SUNSET VILLAGE FILING NO. 4

CONSTRUCTION PLANS

EPC STORMWATER REVIEW COMMENTS
IN ORANGE BOXES WITH BLACK TEXT

PROJECT DESCRIPTION
STRIPING AND SIGNAGE MODIFICATIONS WITHIN SUNSET VILLAGE FILING NO. 4.

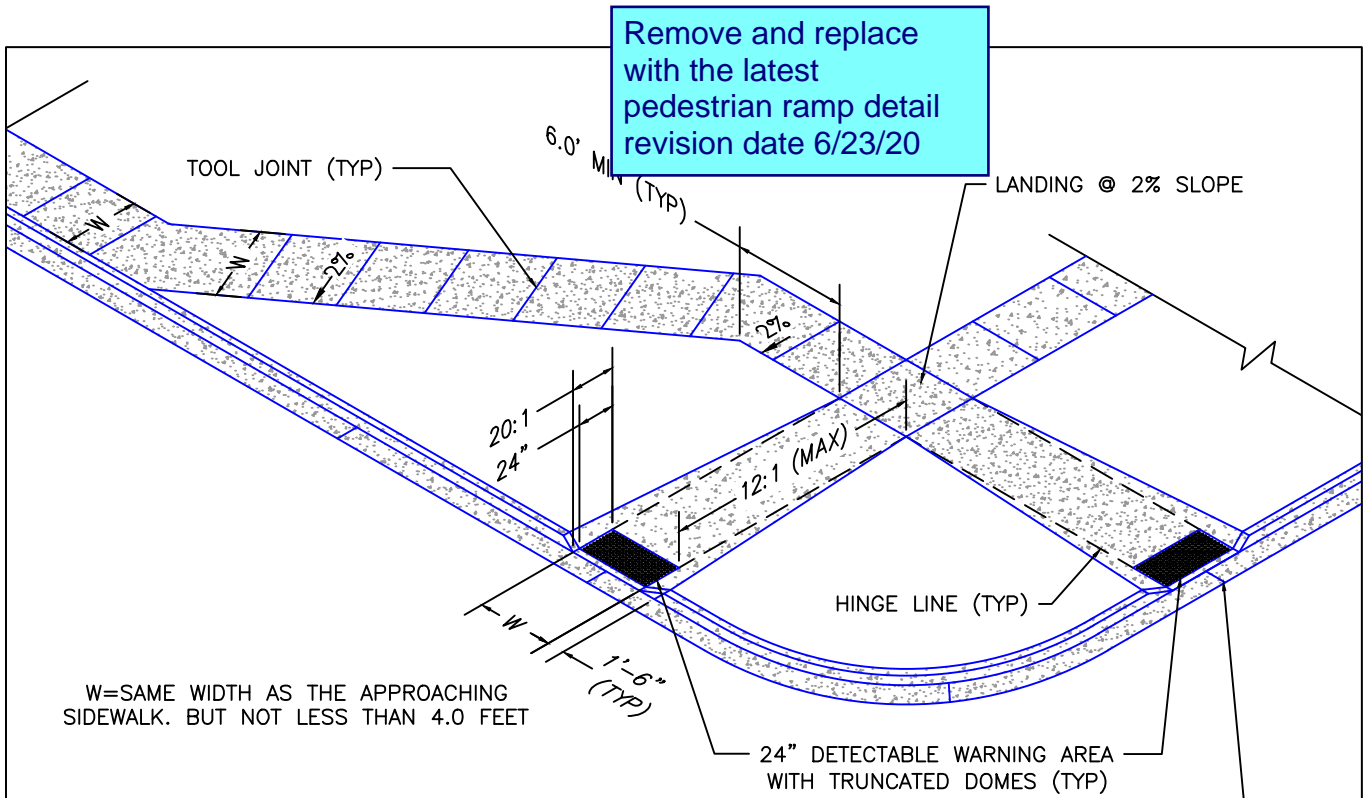
Modify signage striping plan. Per County standard signing and striping note no. 5 "Street name and regulatory stop signs shall be on the same post at intersections.

Identify the size of the stop sign

Add sign post location detail. see CDOT detail S-614-1

Add street name sign at Adrienne Dr and Redtail Dr intersection

Add the County standard signing and striping notes. Attached.

VTC-1. AGGREGATE VEHICLE TRACKING CONTROL

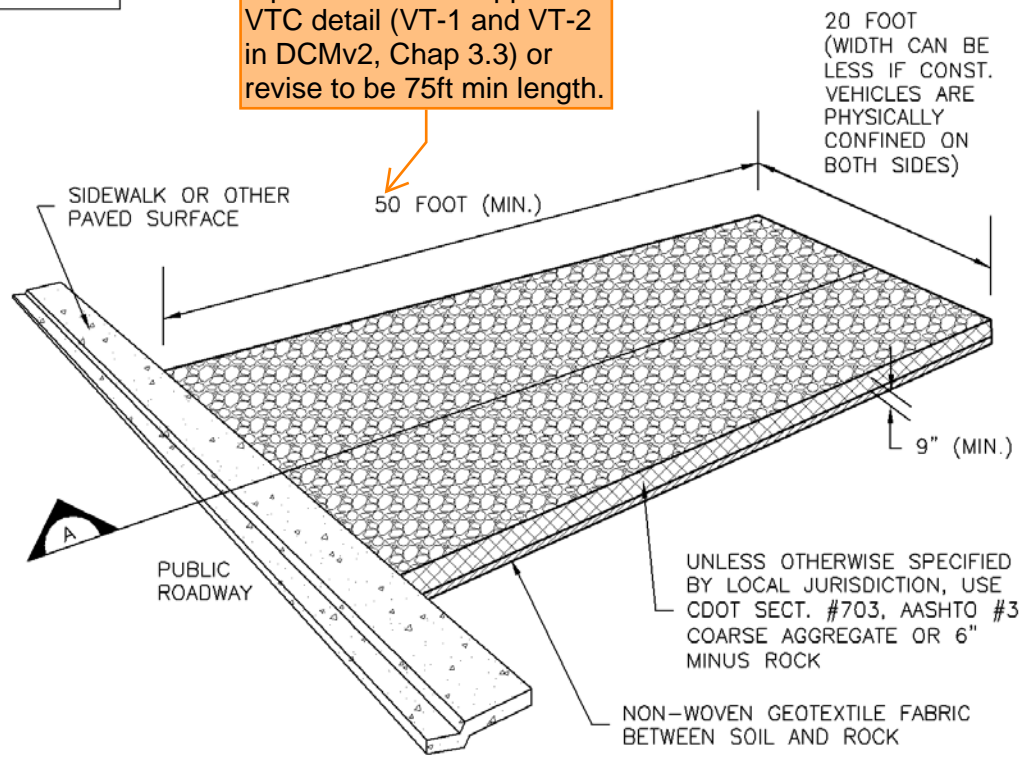
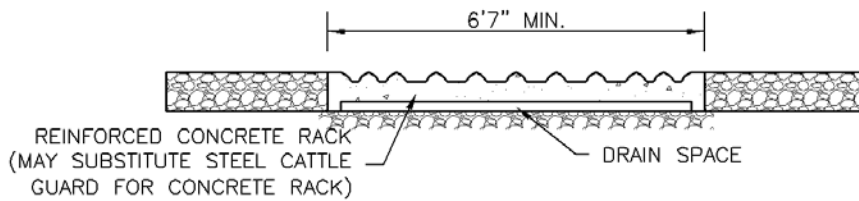
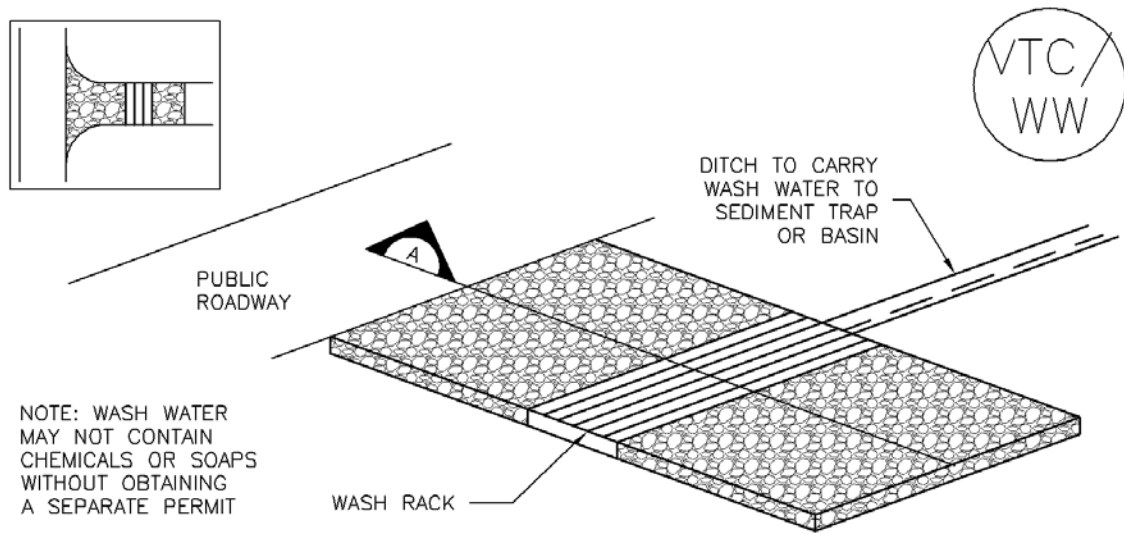
replace with EPC approved VTC detail (VT-1 and VT-2 in DCMv2, Chap 3.3) or revise to be 75ft min length.
